US FOODSERVICE

Issue: Mounting height for visual fire alarms.

**REQUEST FOR WAIVER FROM ACCESSIBILITY REQUIREMENTS
OF CHAPTER 553, PART V, FLORIDA STATUTES**

Name: US Foodservice – South Florida Division

DETAIL FA-2: MAX. STROBE SPACING AT 32' HEIGHT
EQUIVALENT FACILITATION CALCULATION DATA
FOR 150cd STROBE APPLIANCES AT 32' MOUNTING HEIGHT

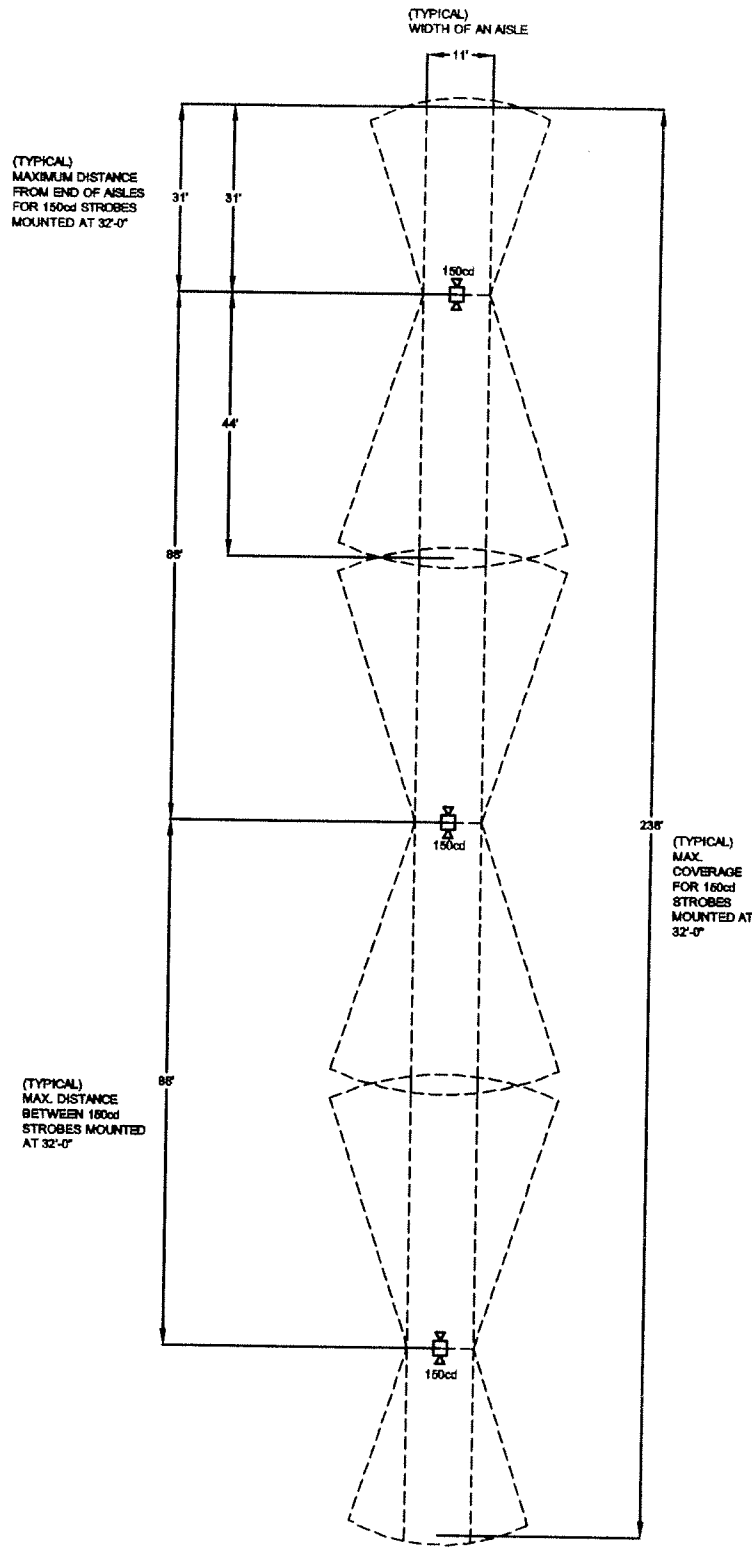
The attached two (2) diagrams (Details FA-2 & FA-3) with explanatory notes document the calculations made to assure compliance. The diagrams and notes provide calculations for the minimum and maximum mounting heights. Intent is to show that either extreme and therefore at any height in between at the maximum spacing shown the required strobe coverage will be met within the warehouse aisle spaces. The attached partial floor plan (Sheet FA-1) depicts typical warehouse aisles, racking and visual notification device location.

4. AS INDICATED ON THE ADJACENT SKETCH, CONSERVATIVE MAXIMUM SPACINGS OF 31' FROM AISLE ENDS AND 88' BETWEEN 150cd STROBE APPLIANCES HAVE BEEN USED AS THE LIMITS FOR SYSTEM PLANS. STROBES ARE TO BE MOUNTED AT THE BOTTOM OF THE ROOF TRUSSES. HEIGHTS WILL VARY WITH ROOF SLOPE. MAXIMUM ACTUAL MOUNTING HEIGHT IS APPROXIMATELY 32'-0"

DETAIL FA-3: MAX. STROBE SPACING AT 35' HEIGHT

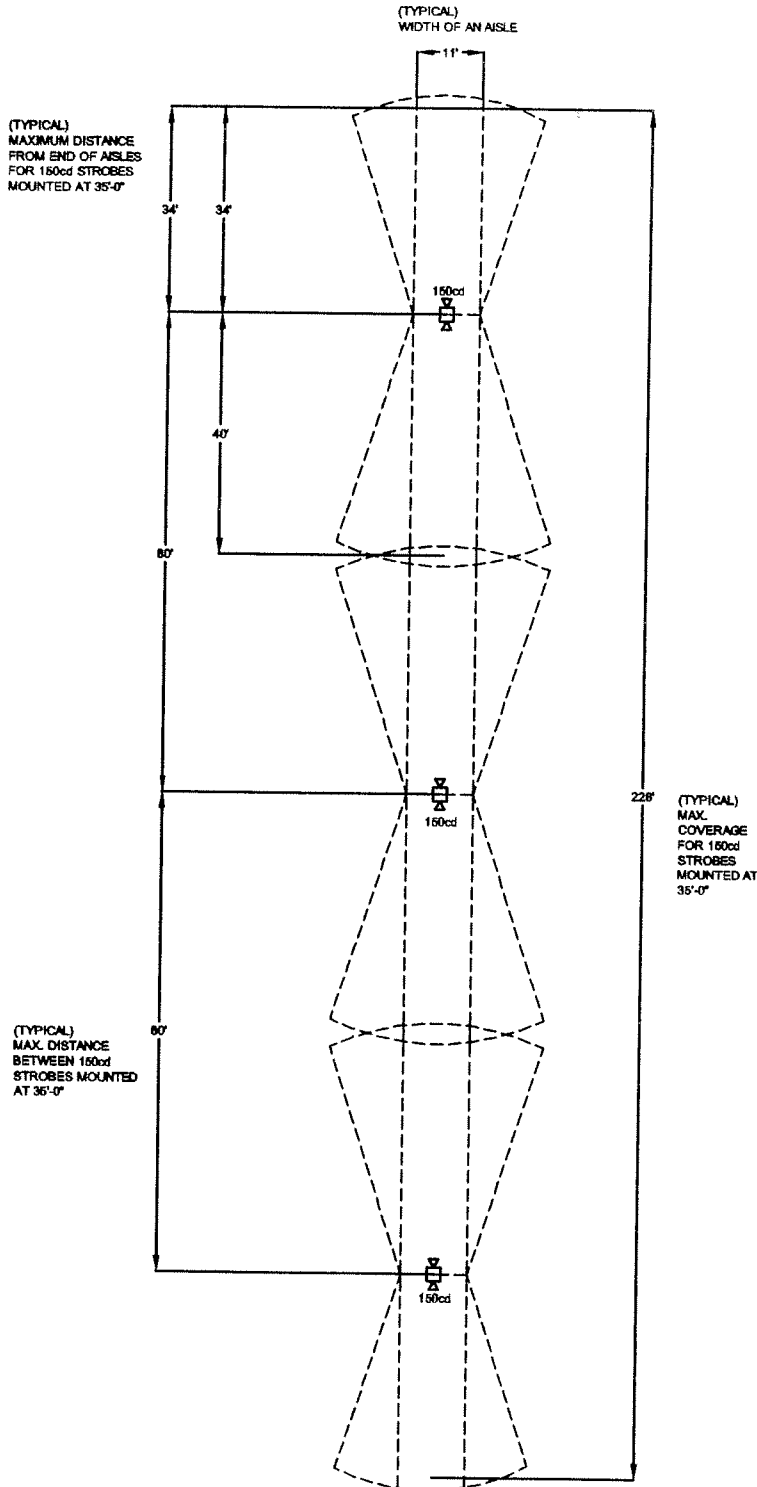
4. AS INDICATED ON THE ADJACENT SKETCH, CONSERVATIVE MAXIMUM SPACINGS OF 34' FROM AISLE ENDS AND 80' BETWEEN 150cd STROBE APPLIANCES HAVE BEEN USED AS THE LIMITS FOR SYSTEM PLANS. STROBES ARE TO BE MOUNTED AT THE BOTTOM OF THE ROOF TRUSSES. HEIGHTS WILL VARY WITH ROOF SLOPE. MINIMUM ACTUAL MOUNTING HEIGHT IS APPROXIMATELY 35'-0"

DETAIL FA-2: MAX. STROBE SPACING AT 32' HEIGHT

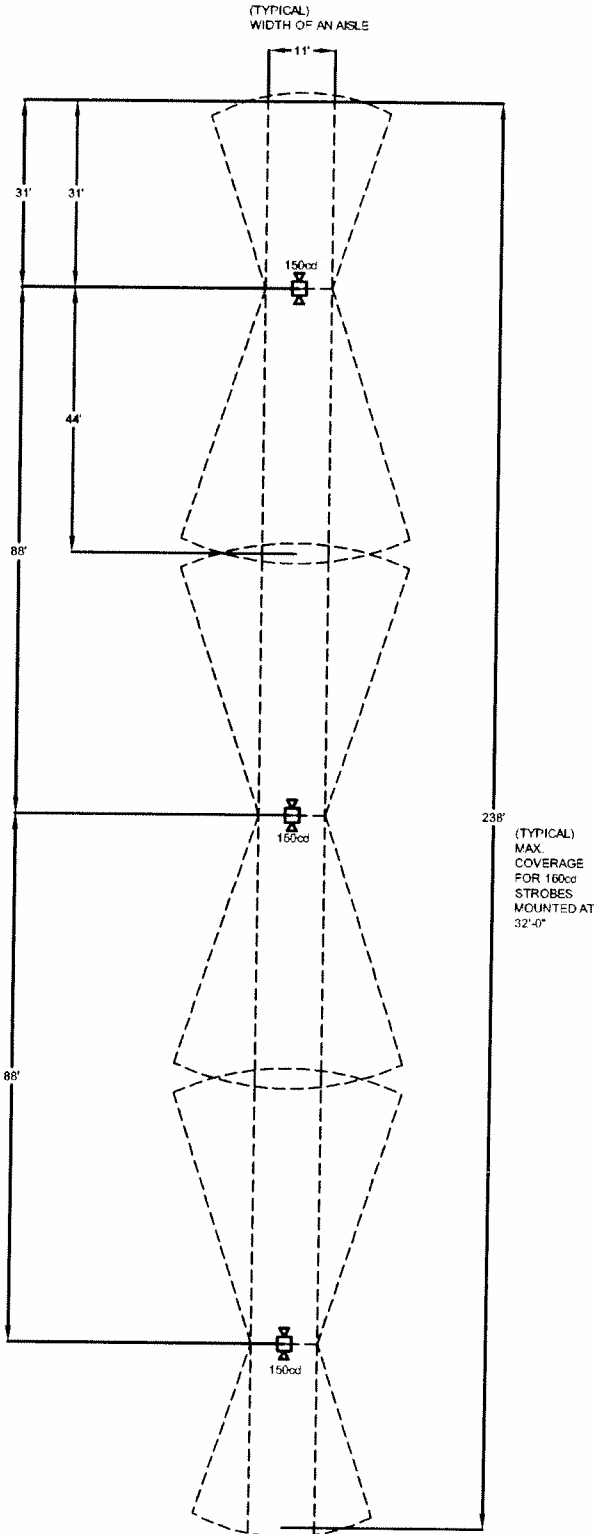
4. AS INDICATED ON THE ADJACENT SKETCH, CONSERVATIVE MAXIMUM SPACINGS OF 31' FROM AISLE ENDS AND 88' BETWEEN 150cd STROBE APPLIANCES HAVE BEEN USED AS THE LIMITS FOR SYSTEM PLANS. STROBES ARE TO BE MOUNTED AT THE BOTTOM OF THE ROOF TRUSSES. HEIGHTS WILL VARY WITH ROOF SLOPE. MAXIMUM ACTUAL MOUNTING HEIGHT IS APPROXIMATELY 32'-0"

(TYPICAL)
MAXIMUM DISTANCE
FROM END OF AISLES
FOR 150cd STROBES
MOUNTED AT 32'-0"

DETAIL FA-3: MAX. STROBE SPACING AT 35' HEIGHT
EQUIVALENT FACILITATION CALCULATION DATA
FOR 150cd STROBE APPLIANCES AT 35' MOUNTING HEIGHT

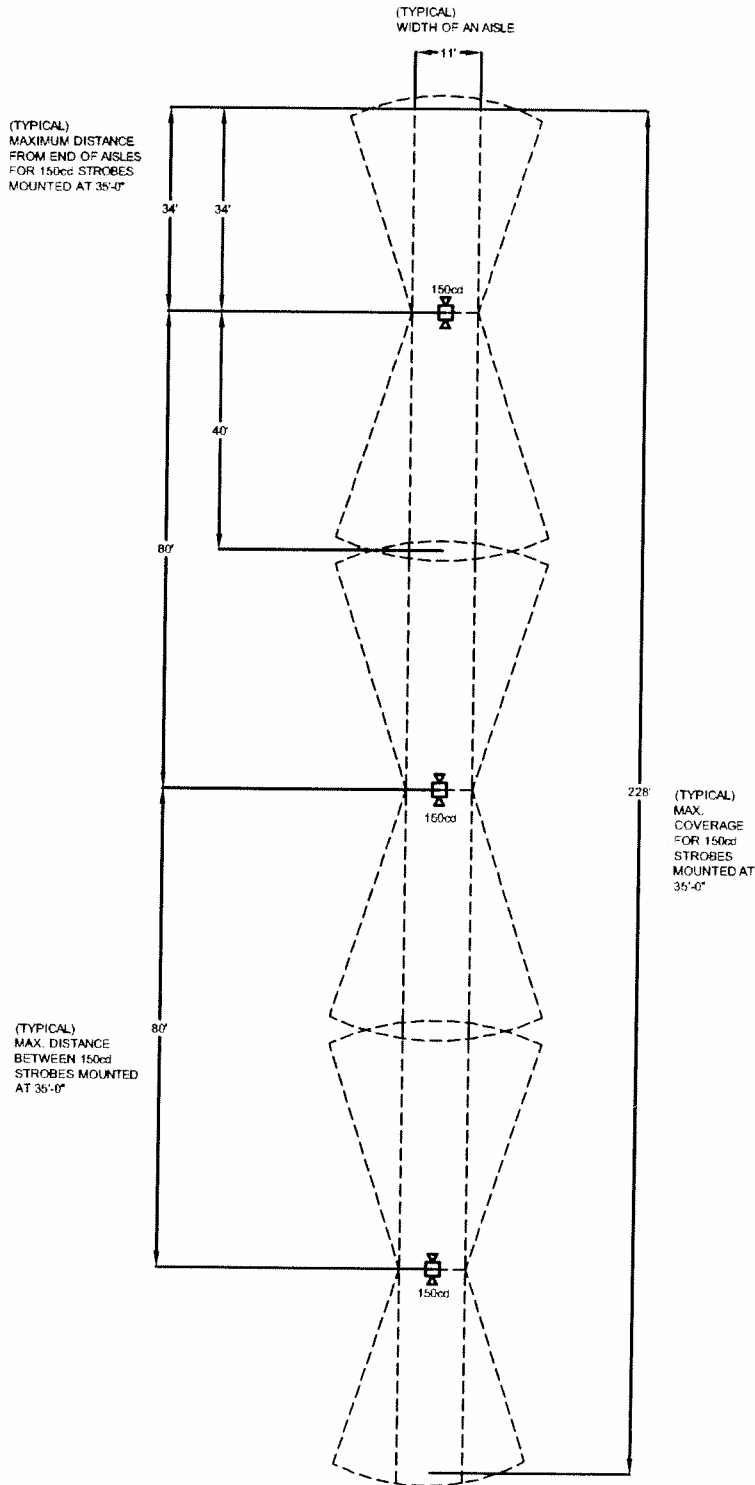
$$\text{MAXIMUM SPACING} = 2 * 41.7' = 83.4'$$
4. AS INDICATED ON THE ADJACENT SKETCH, CONSERVATIVE MAXIMUM SPACINGS OF 34' FROM AISLE ENDS AND 80' BETWEEN 150cd STROBE APPLIANCES HAVE BEEN USED AS THE LIMITS FOR SYSTEM PLANS. STROBES ARE TO BE MOUNTED AT THE BOTTOM OF THE ROOF TRUSSES. HEIGHTS WILL VARY WITH ROOF SLOPE. MINIMUM ACTUAL MOUNTING HEIGHT IS APPROXIMATELY 35'-0"
